RESOURCE CONSERVATION AND RECOVERY ACT FACILITY INVESTIGATION REPORT
ADDENDUM AREA OF CONCERN 602 AND 604 AND SOLID WASTE MANAGEMENT UNIT
106/AREA OF CONCERN 603 ZONE E CNC CHARLESTON SC
8/24/2001
CH2M HILL

RFI REPORT ADDENDUM

AOC 602, AOC 604, and SWMU 106/AOC 603 Zone E

Re: RFI Report Addendum (Revision 0) - AOC 602, AOC 604, and SWMU 106/AOC 603,
Zone E

Figure 2-2
SWMU 106 and AOC 603
Groundwater Sample Location Map
Charleston Naval Complex

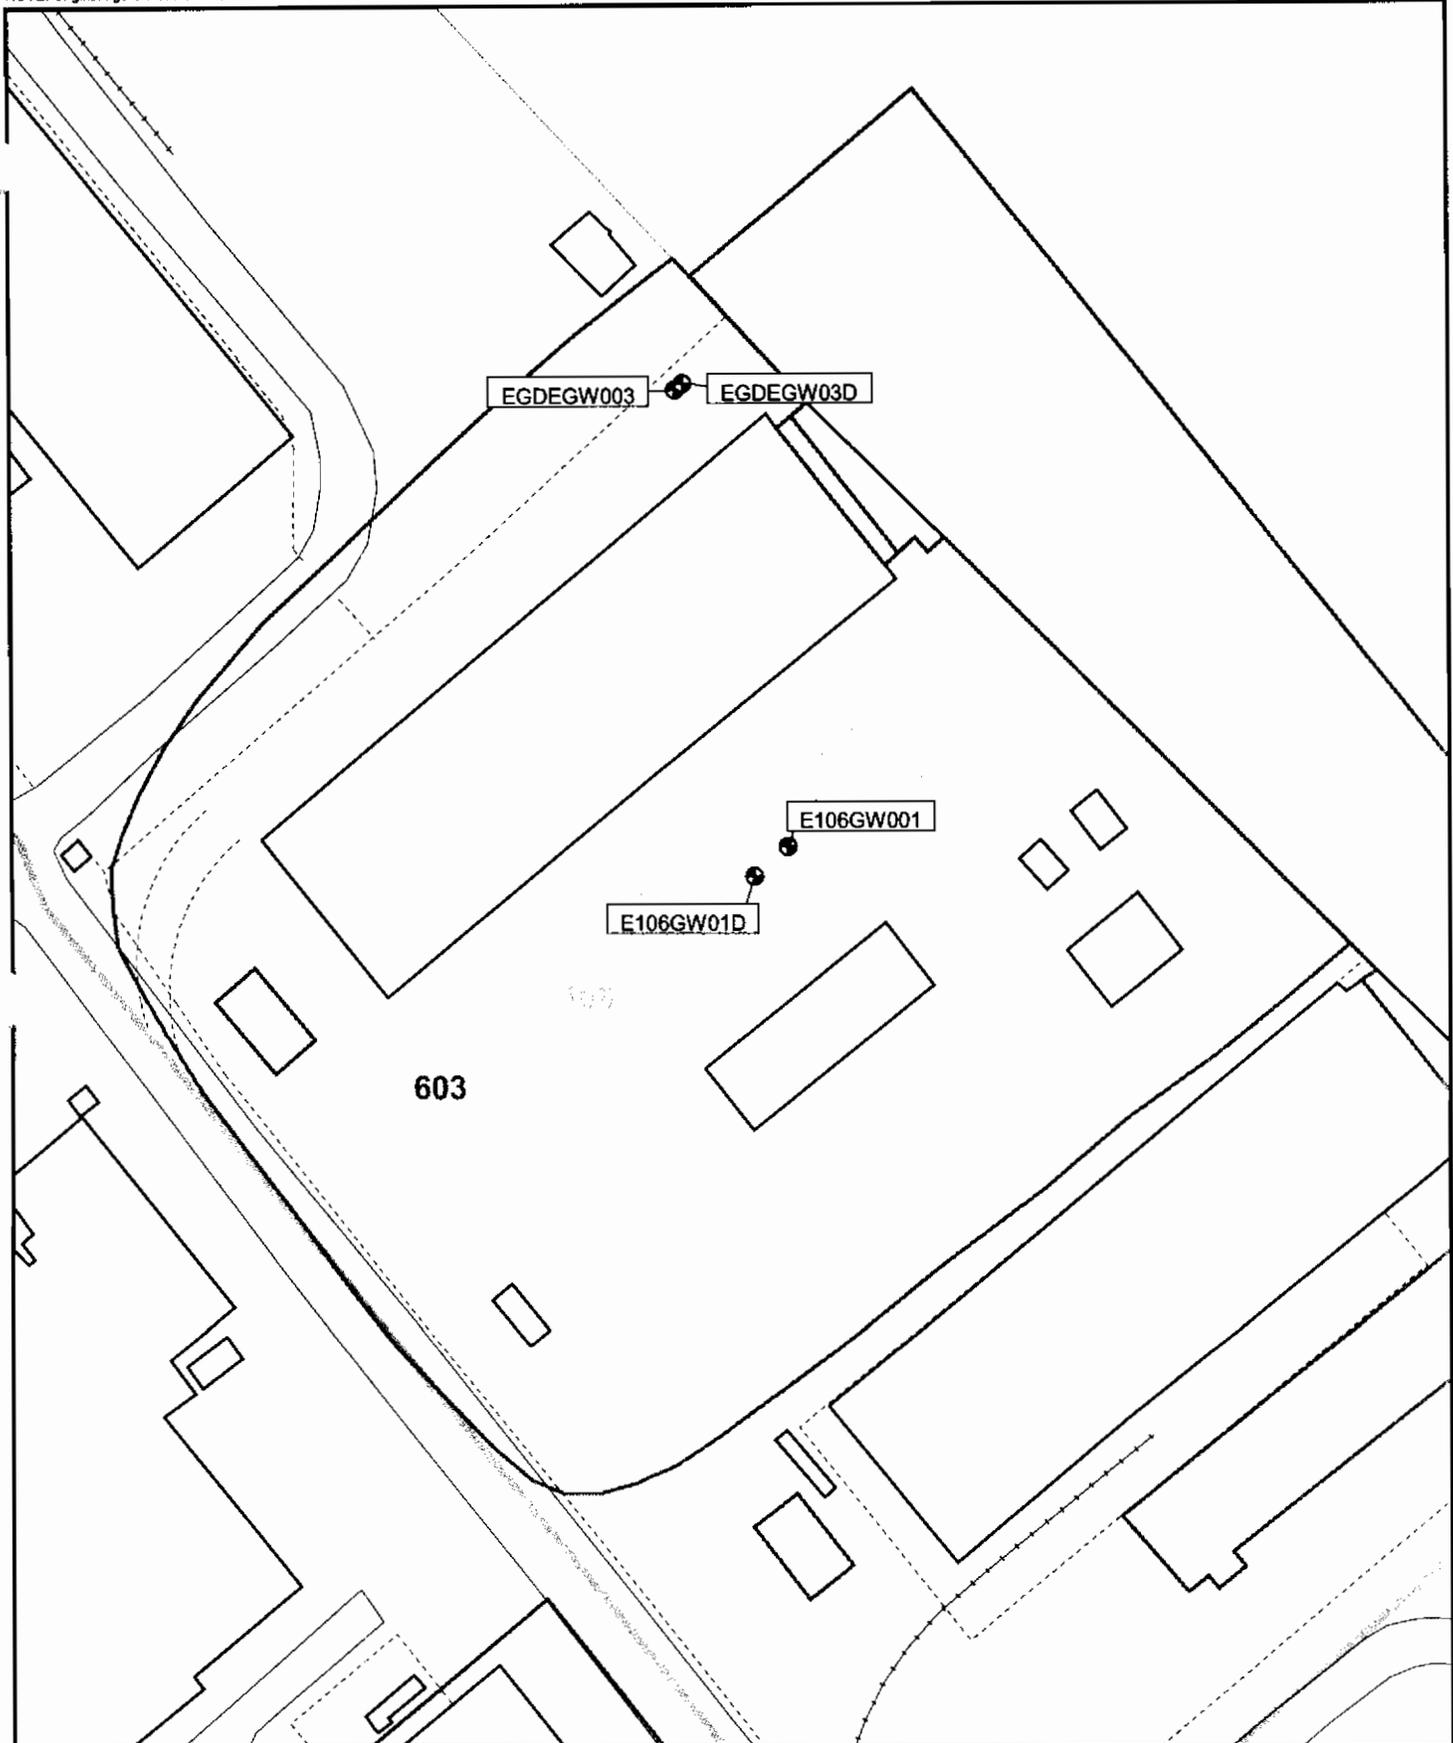
Figure 10.15.6 did not include grid wells NBCEGDE03 and NBCEGDE03D. Please revise.

Figure 10.15.6 will be revised to include both grid well pairs NBCEGDE003/03D and NBCEGDE001/01D. These will be included in the Final Zone E RFI Report.

Following reanalysis of the surface and subsurface soils, it was found that there are no COCs for SWMU 106 (see Section 5.0 of the Zone E RFI Addendum for SMWU 106 and AOC 603). However, grid wells NBCEGDE03 and NBCEGDE03D are included in Figure 2-2 of the Zone E RFI Addendum for SMWU 106 and AOC 603).
